# UNITED STATES PATENT AND TRADEMARK OFFICE

10/772,979

<b>Office Action Summary</b>	<b>Application No.</b> 10/772,979	<b>Applicant(s)</b> BECKER ET AL.	
	<b>Examiner</b> Darwin P. Erez	<b>Art Unit</b> 3773

### DETAILED ACTION

(see attached portion of Fig. 2),

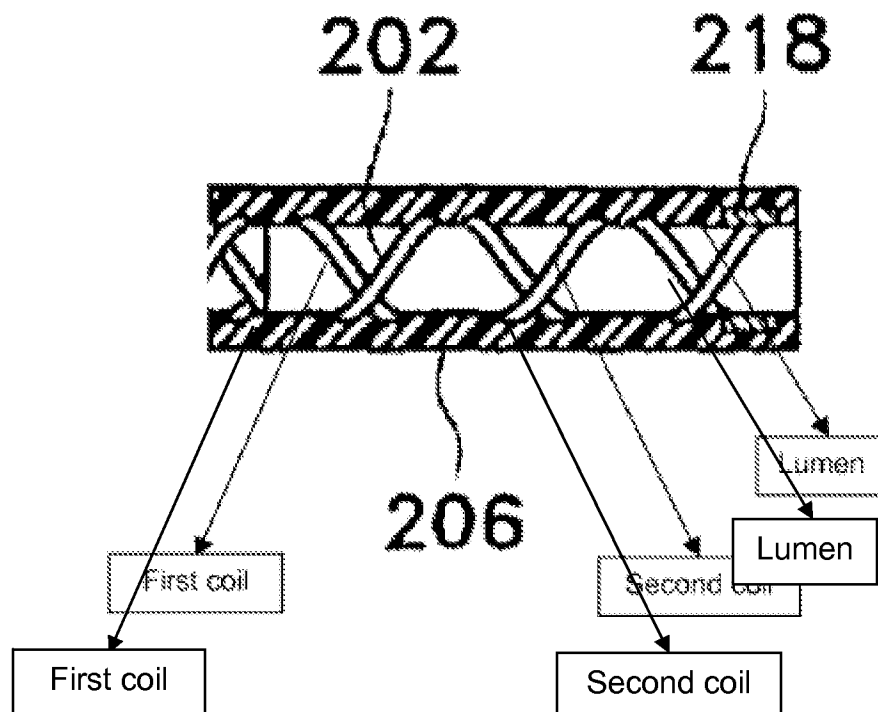
an elongate shaft **200** having a distal end and a lumen (see Fig. 2);

a coil assembly **202** including:

a first coil defining a lumen, the first coil being wound in a first direction

a second coil wound in a second direction, the second coil being disposed around the first coil (as seen below, the second coil is disposed around the first coil);

wherein the coil assembly is attached to the distal end **206** of the shaft, and the lumen of the shaft is in fluid communication with the lumen of the first coil (see attached portion of Fig. 2, below).

Chien discloses a dual coil reinforcement of a hollow tube, wherein the first coil and second coil are braided/weaved around each other. Chien fails to teach the second coil being wound about an outer surface of the first coil.

It is noted that the figure provided by the applicant in page 9 of the Remarks is NOT the device recited in the claim 1. This figure requires: (a) a coil assembly having a tapered/flared end and a diameter that is larger than the diameter of the shaft; (b) the coil assembly having a proximal end attached to the outer surface of the distal end of the shaft. These limitations are not currently recited in the claimed invention. Instead, the examiner's interpretation of the claim, as shown in the figure provided in this Office action, is the broadest reasonable interpretation of the claimed invention.
